TECHNICAL ADVISORY REPORT

IN SUPPORT OF THE JOINT LETTER OF INTENT
FOR TATA STEEL NETHERLANDS

Since November 2022, Mott MacDonald has supported the Dutch government in reviewing the technical aspects of TSN’s Transition Plan that fall within the scope of the tailor-made agreement. The objective of this independent technical review is to provide key insights into the project’s technical maturity, associated uncertainties, and potential opportunities. This technical advisory report sets out the findings of a technical review conducted to support government decision making towards the JLoI.

Figure 9. Predicted CO₂ emissions per (sub)project [6]

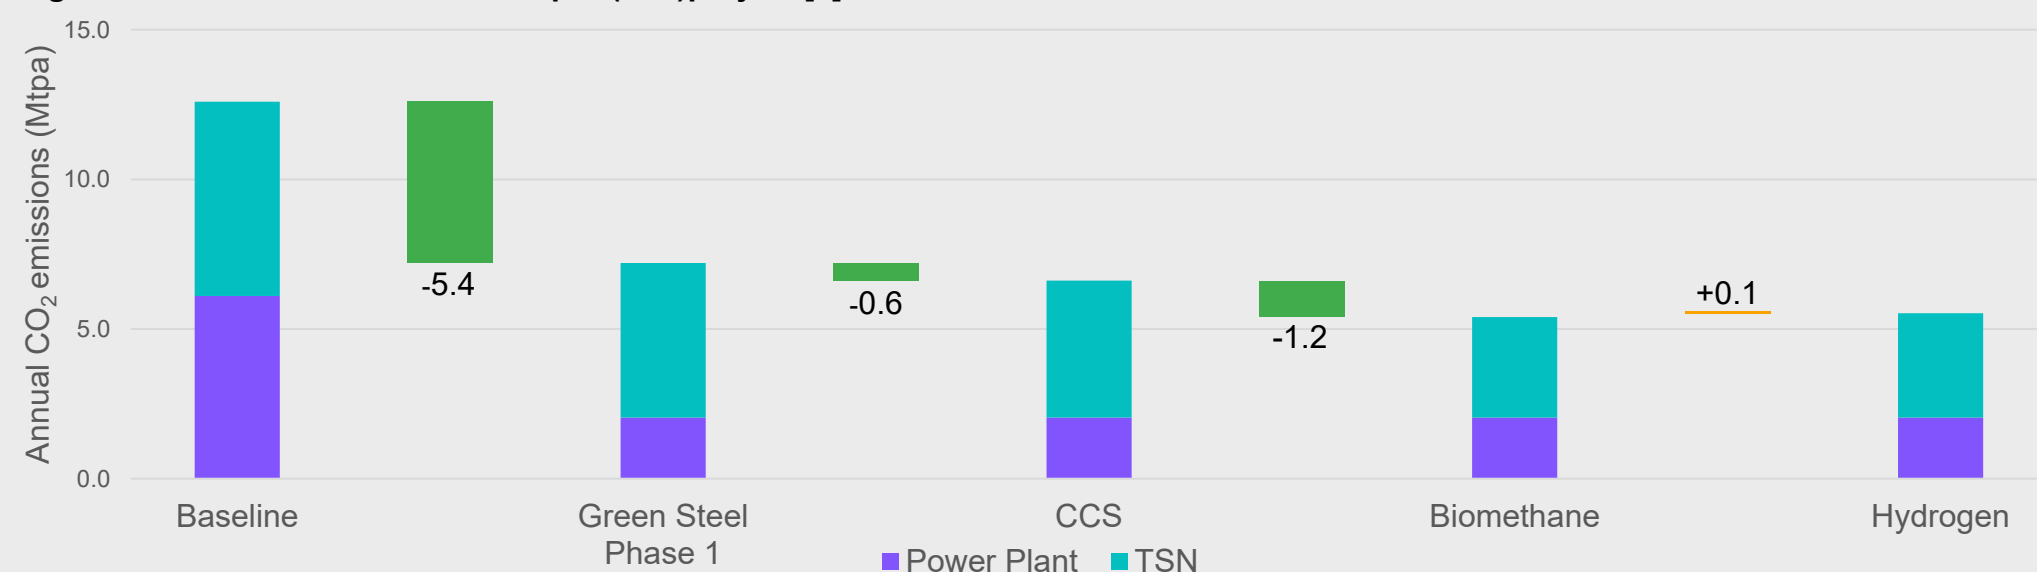
To calculate CO₂ emissions, TSN uses its in-house Carbon (reduction) Selection Model (CSM) which is based on carbon mass-balance principles and historical data for the existing assets. The material flows for the new assets (DRP-EAF) are sourced from databooks provided by the Original Equipment Manufacturers (OEMs). Overall, the methodology is considered appropriate and in line with industrial best practice. However, some uncertainties are identified:

- Only the major assets onsite are included.
- Minor carbon flows (e.g. scrap and steel products) are excluded.
- Only CO₂ is included; other greenhouse gasses are omitted.
- The coking time of CGP1 will increase once Green Steel Phase 1 is implemented. This operational change can impact the material balance over CGP1, but is not completely reflected in the calculations.
- Some consumption factors in the CSM differ from source documents.

A margin of 0.6 Mtpa has been agreed upon in the JLoI. This margin is considered sufficient to allow for any of the above-mentioned uncertainties to materialise. Therefore, it is likely the stated CO₂ objectives in the JLoI can be achieved with Green Steel Phase 1. The scope of this review only covers scope 1 emissions, scope 2 and 3 emissions are specifically not part of this review.

Figure 11. TSN's predicted PM₁₀ immission contribution reductions in WaZ [6]

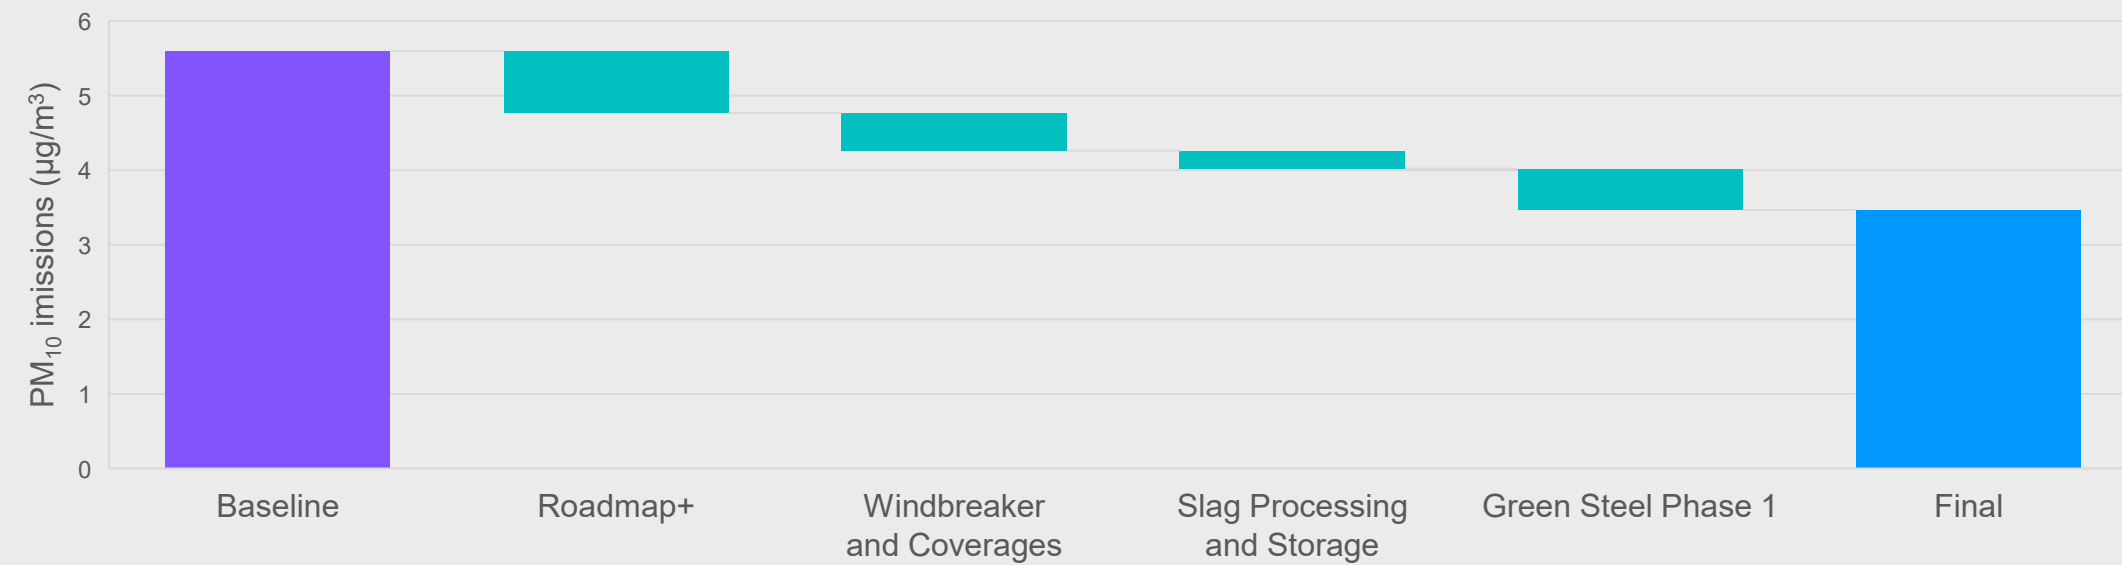
TSN estimates its 2019 baseline immission contribution in WaZ at 5.6 µg/m³, including chain partners Harsco and PHY. To meet the 35% target, a reduction of approximately 2.0 µg/m³ is required (Figure 11). TSN predicts a 38% reduction (2.1 µg/m³) through combined measures (reduction percentages and totals may differ due to rounding):

The PM₁₀ immissions have been calculated using TSN's emissions data and dispersion industry-standard dispersion modelling software. While this approach aligns with industry best practice, and dispersion modelling is the appropriate tool for predicting future immissions, this introduces additional uncertainty such as not being able to predict future meteorological conditions and how the model calculates pollutant dispersion. Independent baseline immissions estimates by RIVM, derived from alternative modelling and monitoring data analyses, range from 4.6 to 7.4 µg/m³. TSN's baseline immission estimate of 5.6 µg/m³ falls within this range. However, the spread of values highlight the inherent uncertainty in immission modelling.

Figure 12. PM₁₀ immission reduction in WaZ from the Windbreaker and Coverages [6]

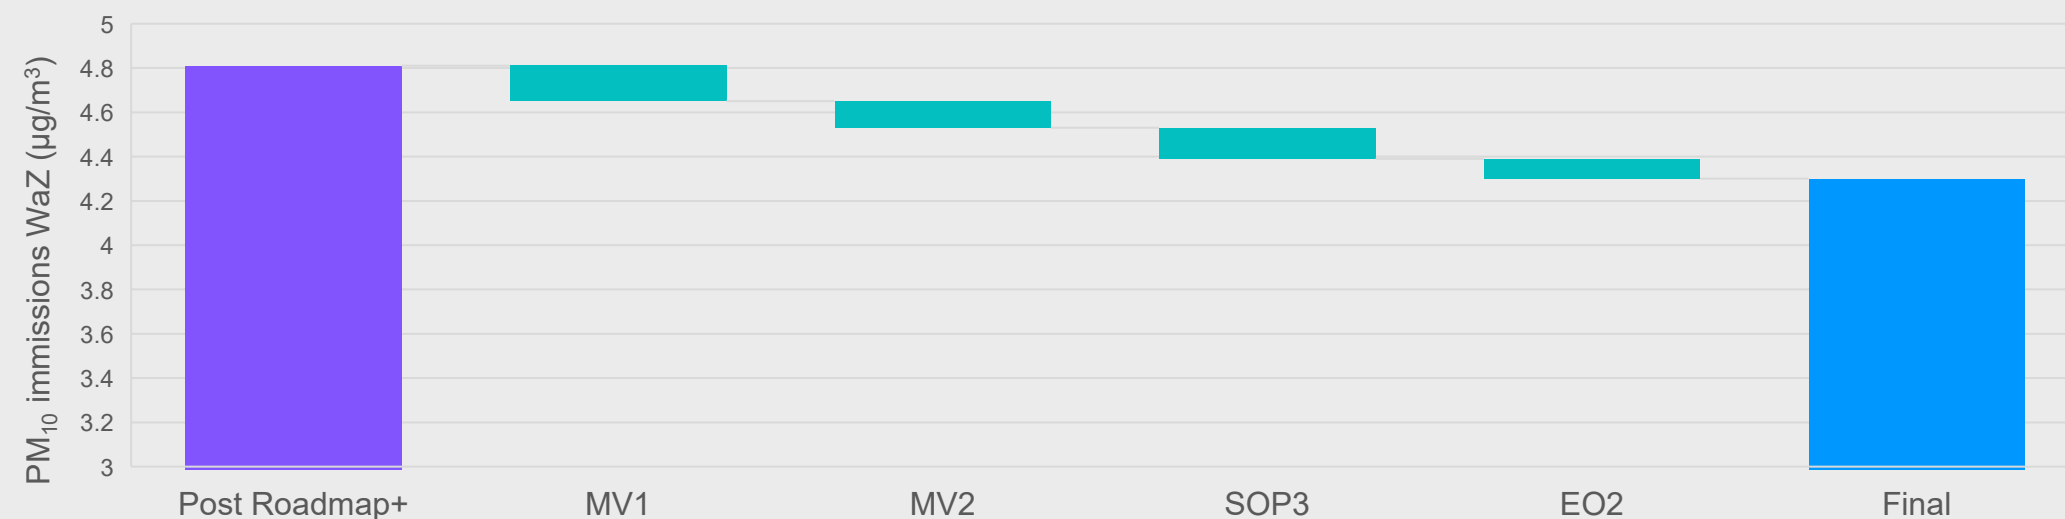
Measures include a windbreaker at MV1 and coverages at MV2, EO2, and SOP3. These are predicted to reduce PM₁₀ immissions by ~0.5 µg/m³ (~9%) (see Figure 12). As detailed on page 15, TSN's calculations have used emission factors from national guidance and dispersion modelling by an independent consultant. Reduction factors applied (90% for full coverages and 50% for the windbreaker) are supported by published literature and wind simulation data. This methodology aligns with industry best practice, however the predicted reductions are subject to uncertainty due to the cumulative effects of:

Figure 18. Two Water Granulation Concepts [16]

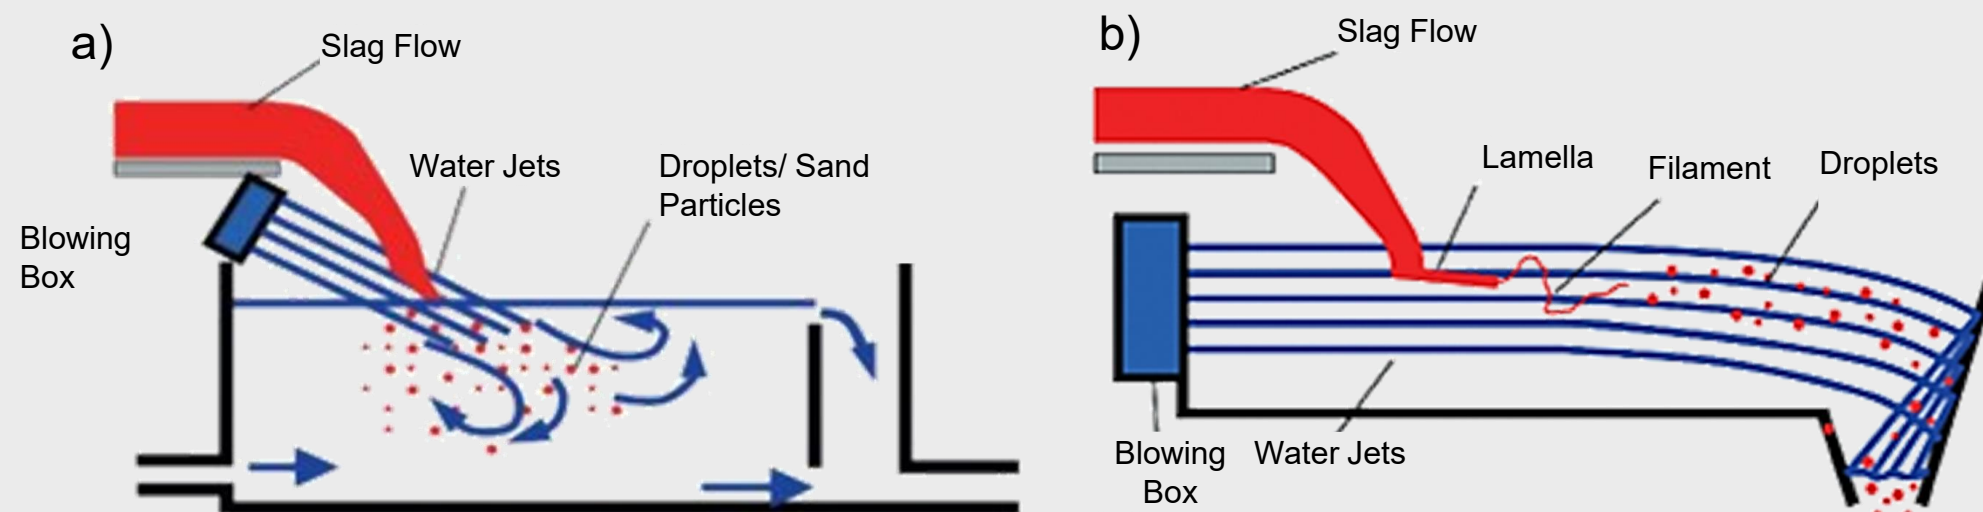
TSN has selected water granulation as the preferred processing method after evaluating alternatives. This process rapidly cools molten slag with water jets to form glass-like granules (Figure 18). TSN currently uses water granulation for blast furnace slag, which is widely used as SCM.

Future regulatory changes on heavy metals could significantly impact the viability of slag applications. TSN has acknowledged that stricter limits on chromium and vanadium could pose a major challenge.

TSN's slag processing and application plan is in early stages of development. The current plan relies on a technology and application pathway that is not yet proven at the required scale. Significant challenges and uncertainties remain regarding technical feasibility, certification, and environmental compliance. A clear and detailed development roadmap, supported by OEM commitments and independent testing, will be essential to reduce these uncertainties. Due to the uncertainties with water granulation, TSN is engineering quench cooling as fallback option, which is considered a more proven technology, although challenges with SCM application remain.

Figure 19. Phase-by-Phase and Total CapEx for Green Steel Phase 1 [6]

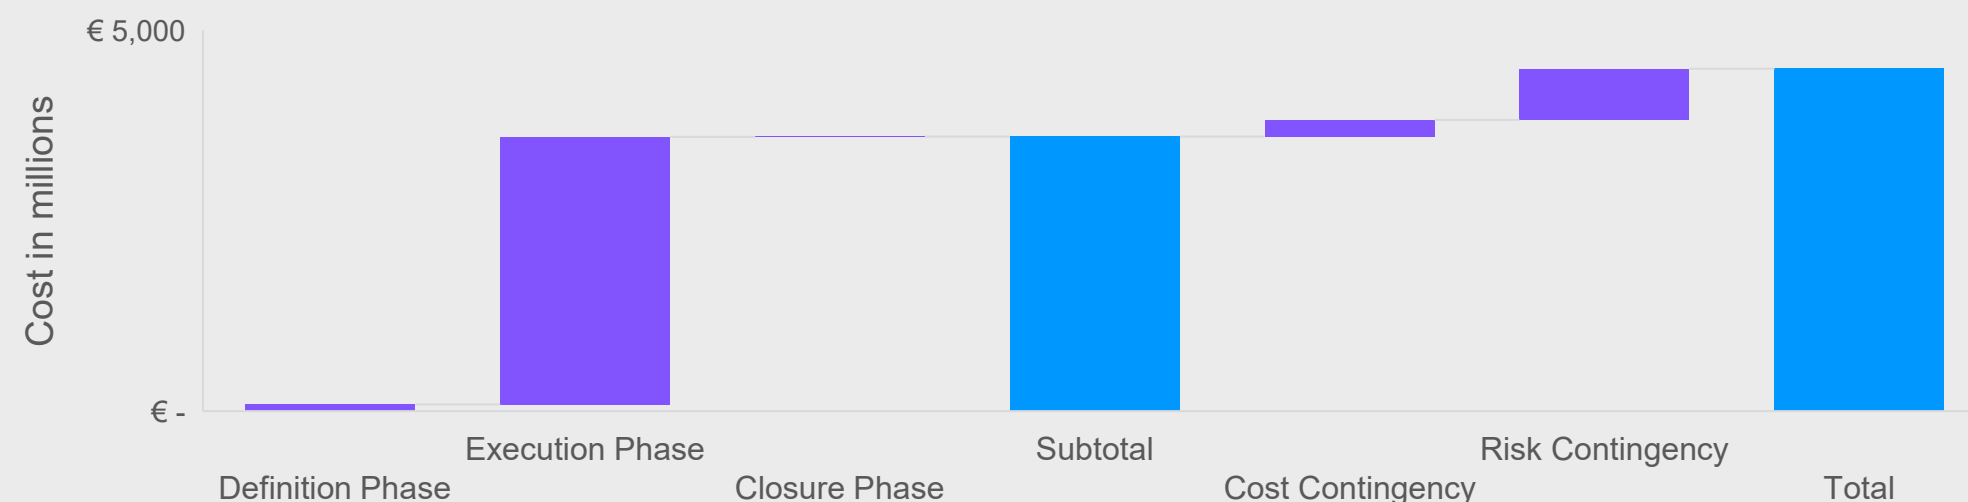
TSN's total CapEx allowance for Green Steel Phase 1 is approximately €3.6 billion, excluding contingency and risk provisions. When these are included, the total rises to around €4.5 billion. The estimate is structured across three phases (see Figure 19):

- **Cost contingency:** TSN has included 6%, which is considered low given the level of definition. A contingency of ~10% would be more appropriate.
- **Risk contingency:** Currently 19%, based on an outdated risk assessment, but considered broadly reasonable.

Figure 20. CapEx estimate Windbreaker and Coverages [6]

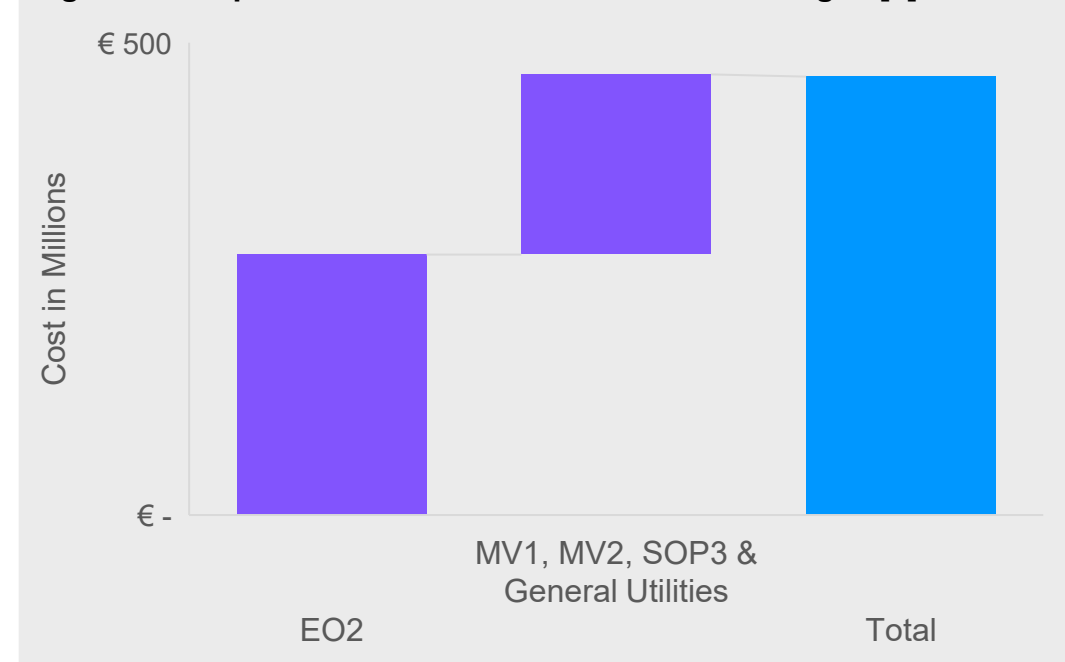
TSN's total CapEx allowance for the Windbreaker and Coverages project is approximately €465 million, divided across four main storage areas (EO2, MV1, MV2, SOP3) and General Utilities (Figure 20). The estimate is structured as follows:

EO2 accounts for 60% of total project costs (~€275 million) and is at FEL1/2 maturity. Current contingency is 17%, which is low given the early stage and identified issues. A contingency of 25% is considered more appropriate. As this estimate accounts for 60% of the total programme costs, this significantly affects the total integrity of the cost estimate.

Figure 21. Accuracy of the CapEx estimates per asset [6]

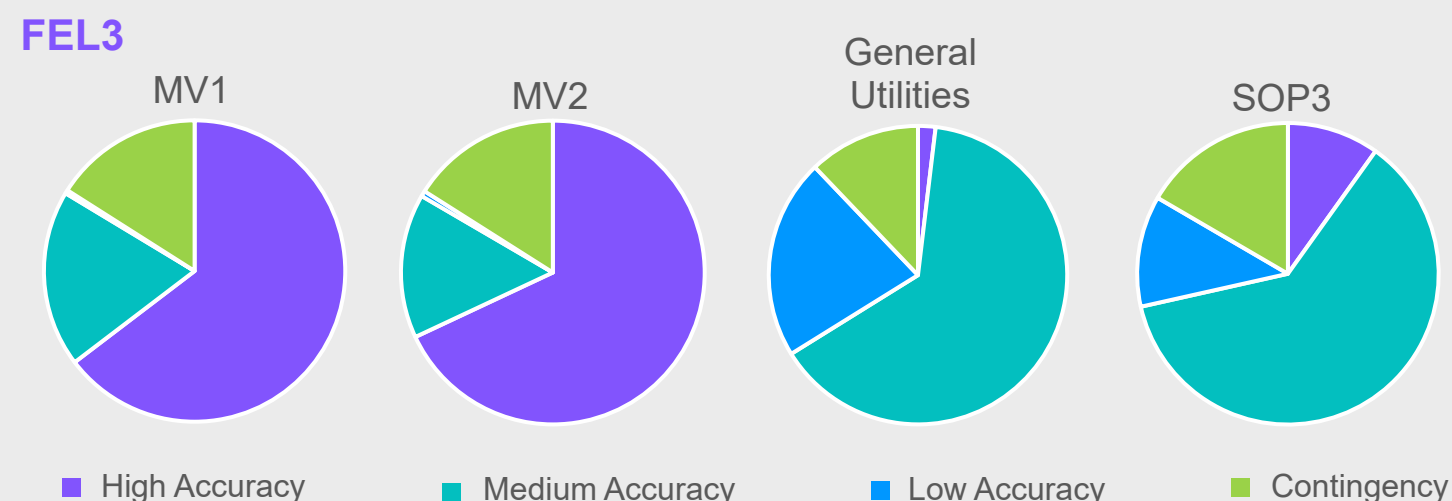
- **MV1 and MV2:** Data accuracy is medium to high (Figure 21), supported by budget quotes and benchmarks.
- **SOP3 and General Utilities:** Data has a lower accuracy, with limited breakdowns and reliance on in-house estimates. No detailed breakdown was provided for project management office costs, which introduces uncertainty.
- **Contingency:** for general utilities is lower than for other areas, despite higher uncertainty.

Figure 22. Total CapEx Slag Processing and Storage [6]

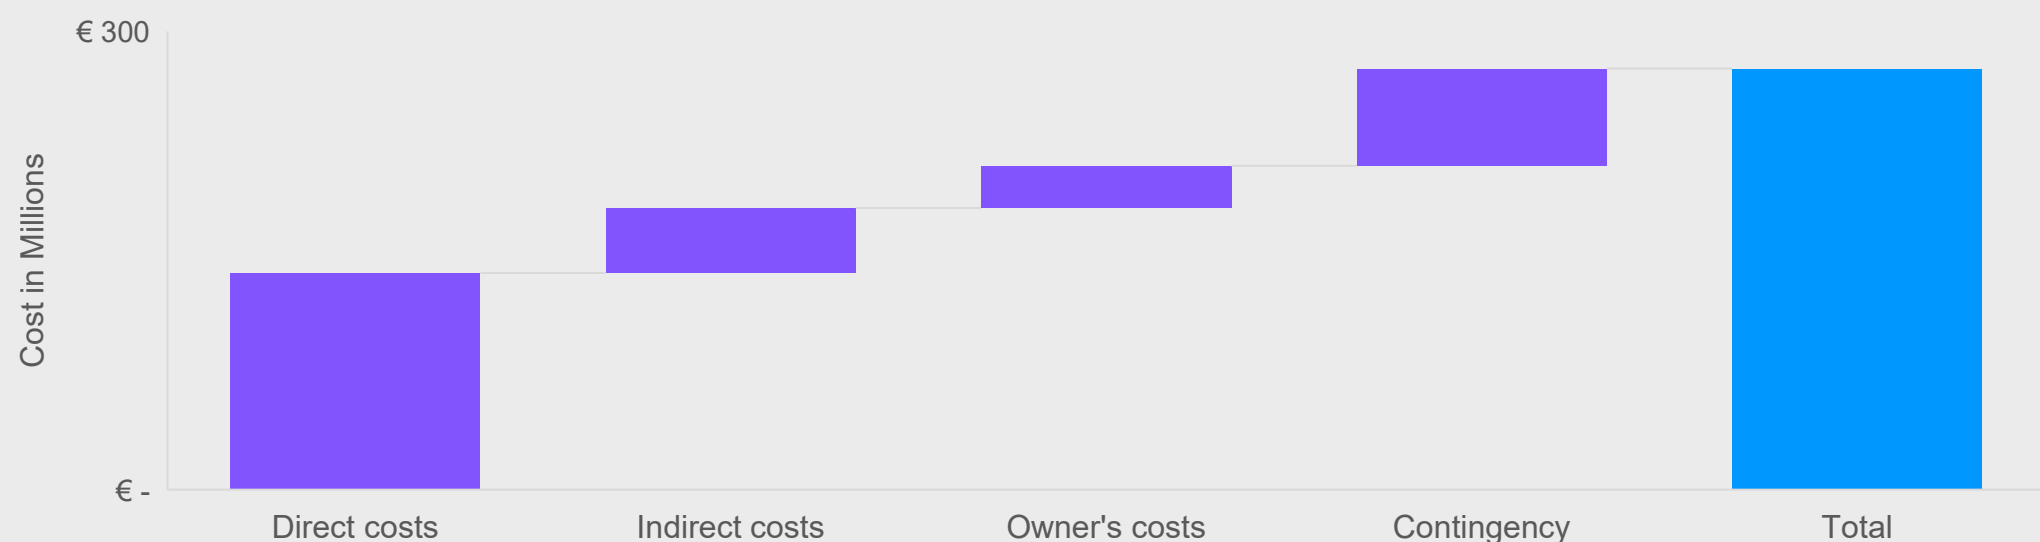
The estimate uses historical data from similar systems. The proposed flow rate is 500,000 m³/h, with the estimate scaled down from larger reference plants. The approach is considered reasonable.

A contingency of 30% is applied to the total estimate. This is in line with expectations for FEL1 maturity.
